U.S. Department of Energy  
**Office of River Protection**

11-ESQ-241

U.S. DEPARTMENT OF ENERGY (DOE), OFFICE OF RIVER PROTECTION (ORP)  
SUBMITTAL OF CLOSURE REPORTS FOR SIX EMISSION UNITS IN THE HANFORD  
SITE AIR OPERATING PERMIT (AOP), PERMIT NUMBER 00-05-006/LICENSE NUMBER  
FF-01

Report of Closure for Emission Units

Document/Drawing No. H-14-030013 Sheet 3 Revision 5

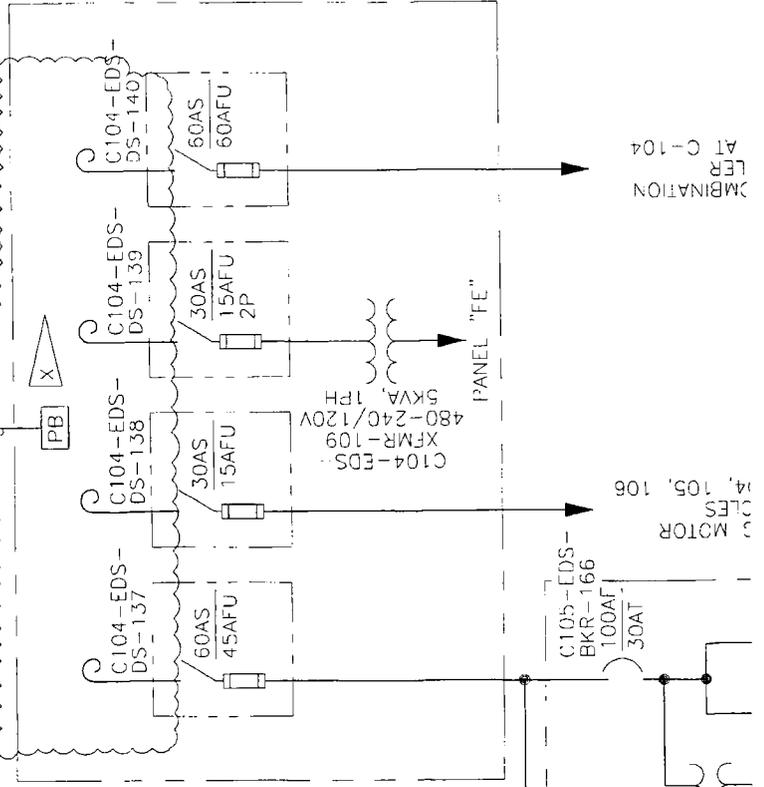
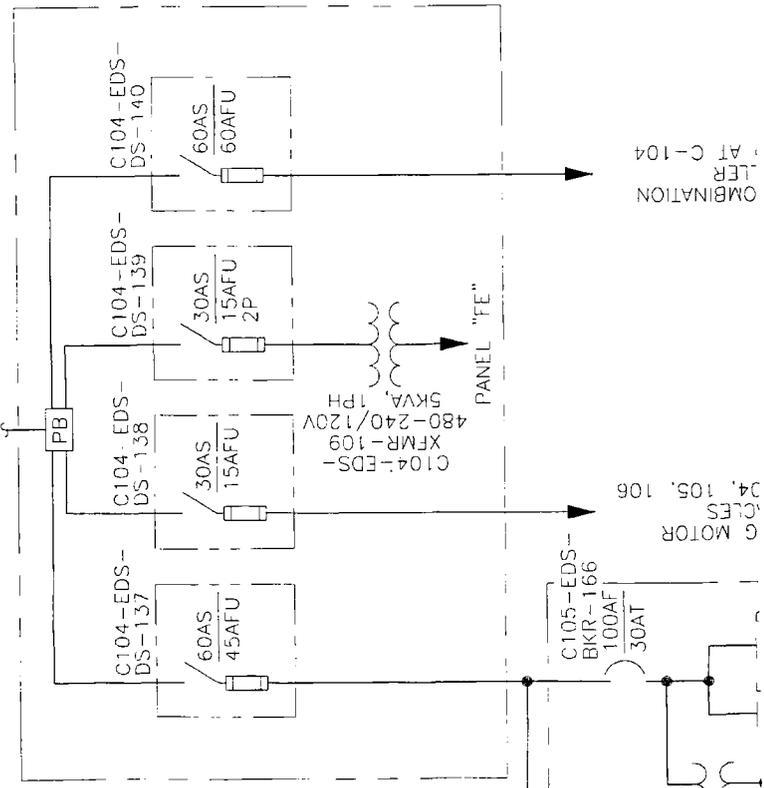
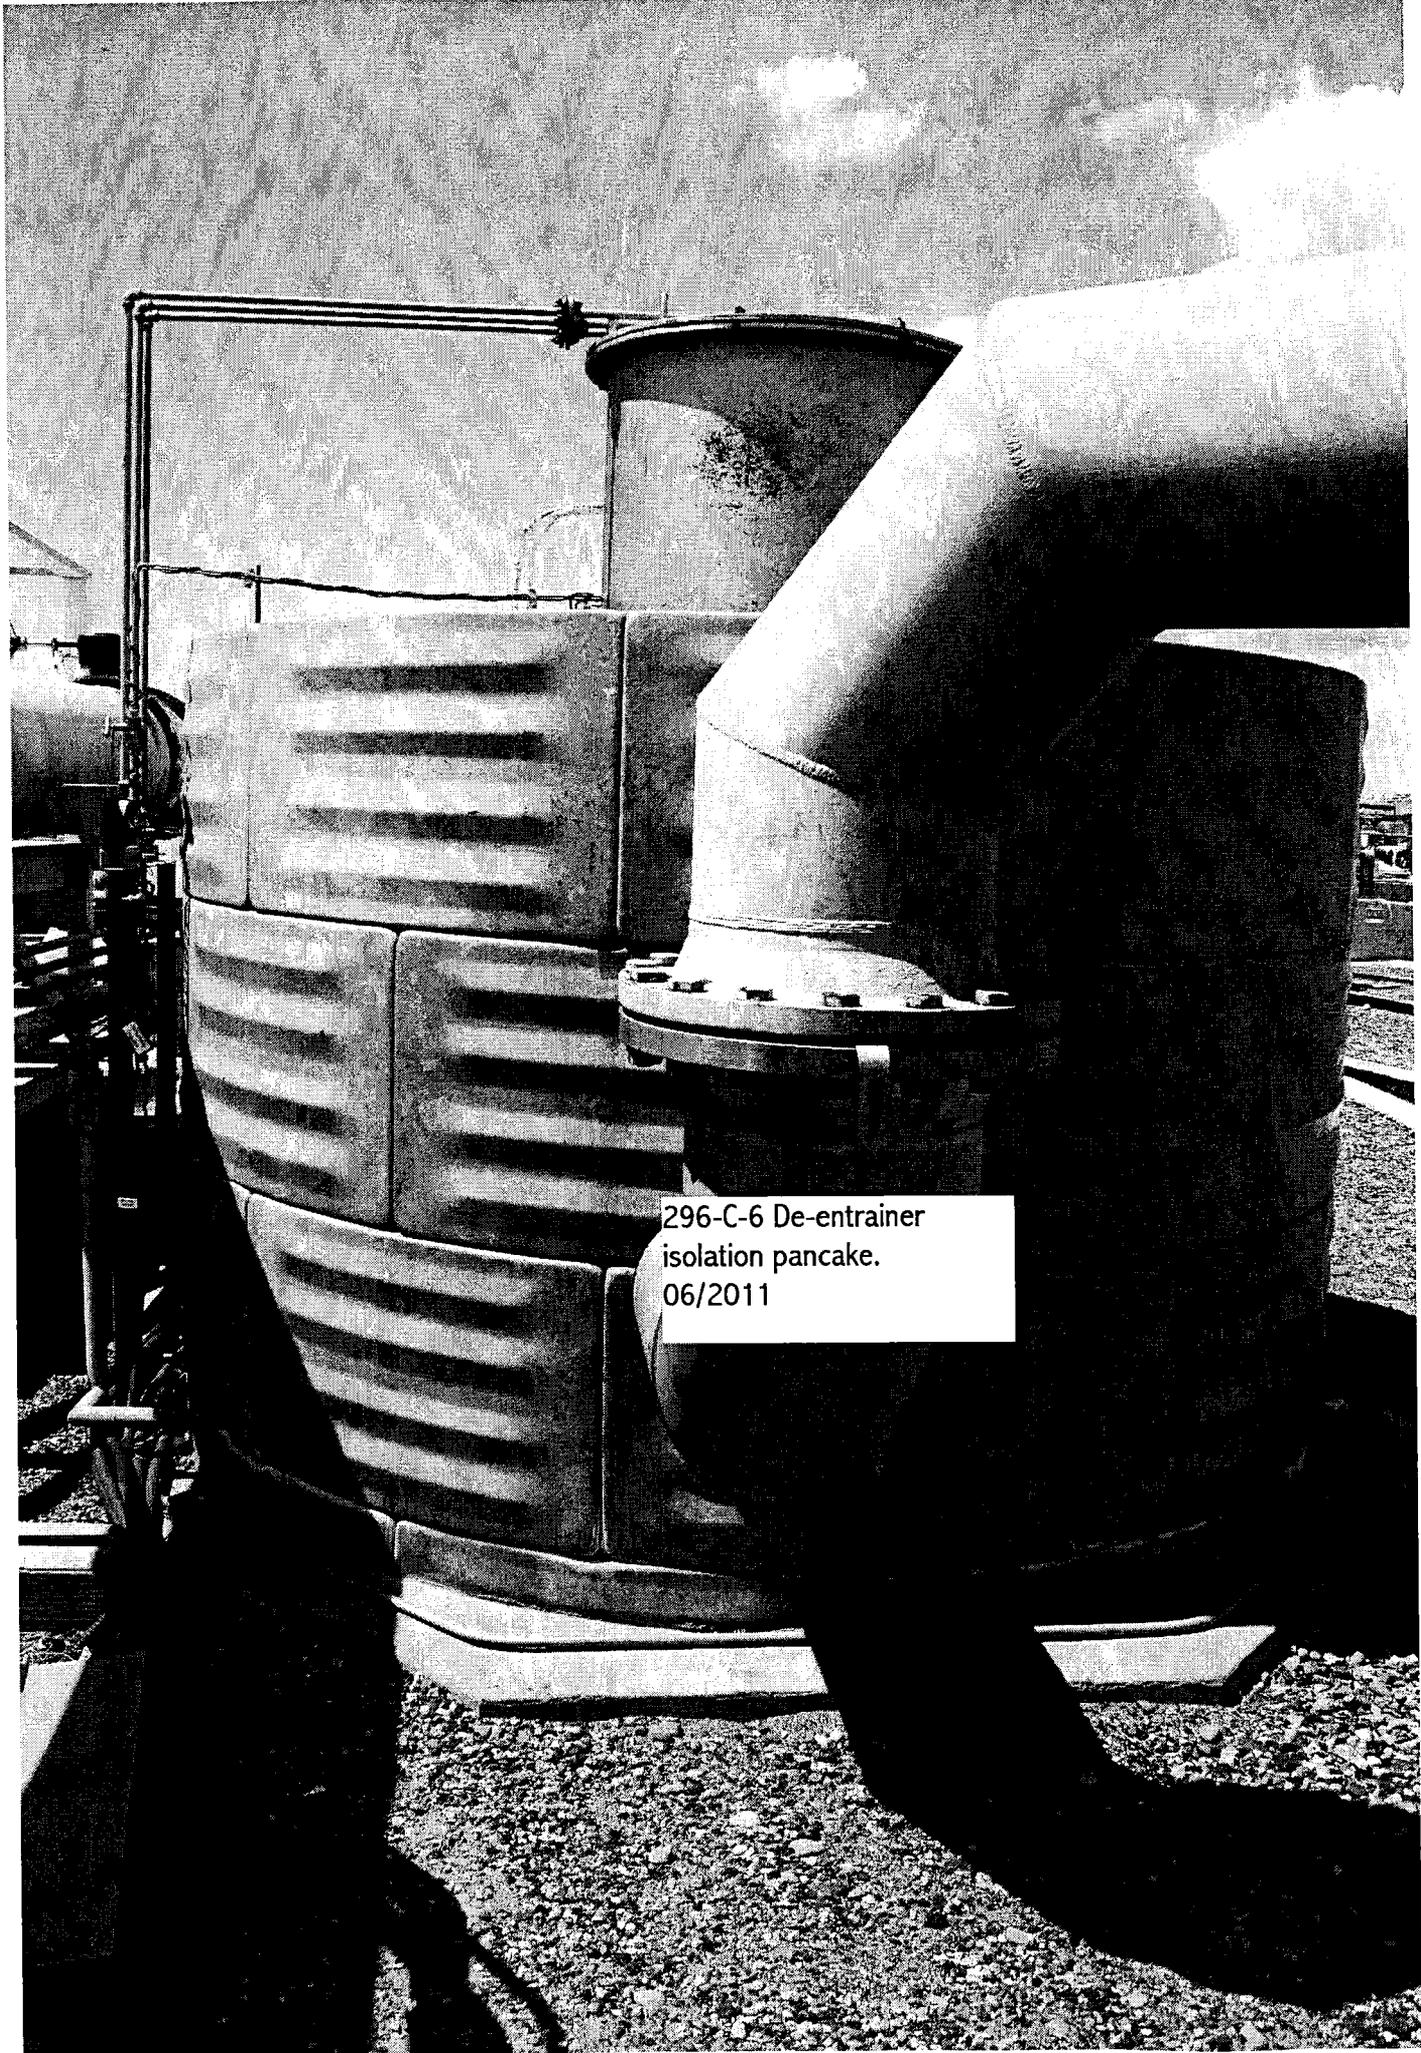
ECN NOTE: DELETE OR REVISE CLOUDED AREAS ONLY
